Peach Bottom Atomic Power Station, Units 2 and 3  
Facility Operating License Nos. DPR-44 and DPR-56  
NRC Docket Nos. 50-277 and 50-278

Subject: Response to Request for Additional Information Related to Time-Limited Aging Analyses

**Exelon Generation Company, LLC (Exelon)  
License Renewal Application (LRA)  
Peach Bottom Atomic Power Station (PBAPS), Units 2 and 3**

**Request for Additional Information**

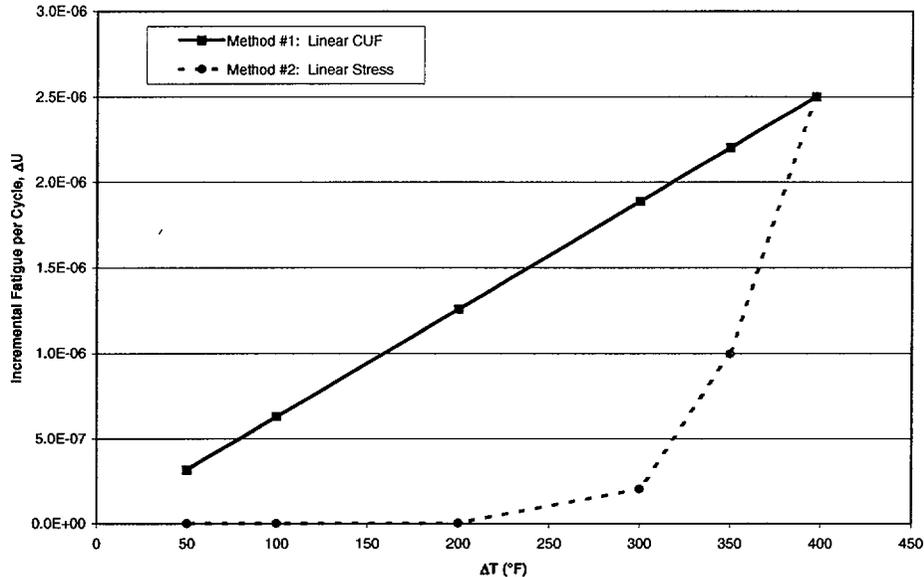
Section 4.3.2.1 of the LRA indicates that fatigue analyses of the core shroud supports were reevaluated for effects of increased recirculation pump starts with the loop outside thermal limits. Describe the reevaluations that were performed considering an increase in recirculation pump starts. Indicate the reason that the reevaluations were necessary.

At issue are thermal events associated with the PBAPS Technical Specification requirement that limits the temperature difference ( $\Delta T$ ) between an idle recirculation loop and the vessel coolant to be within 50°F of each other prior to pump start. Specifically of concern is the  $\Delta T$  following initiation of the first of two idle recirculation pumps. Since PBAPS has experienced events of this type in the past, the plant Technical Specifications requirements triggered the evaluations in question.

The design basis Sudden Start event provides conservative and convenient criteria for accounting for the actual events experienced at the PBAPS units. This design basis event is much more severe than the events actually experienced at PBAPS, as the actual  $\Delta T$ s were significantly lower than the  $\Delta T$  evaluated for the design event. Since the design basis event consists of a very conservative step change in temperature, the fatigue contribution for this event is driven almost exclusively by the  $\Delta T$  during the event. Therefore, the  $\Delta T$  of the actual events were compared to the  $\Delta T$  of the design basis events to establish partial cycle counts for these events. This method leads to revised CUF estimates that are linear with respect to  $\Delta T$ , which is conservative compared to more traditional CUF estimates where stress is linearly related to  $\Delta T$ . The conservatism of this method is demonstrated in Figure 1. Since the Sudden Start event is a primary contributor to the shroud support CUF value, this component was selected for evaluation of these events. Other affected RPV and piping locations were also evaluated, but were less limiting than the shroud support from a CUF perspective. Note that although the shroud support is not an ASME Code pressure boundary component, it was considered in this evaluation since it was included as a part of the original ASME Code, Section III design basis evaluation for the reactor pressure vessel.
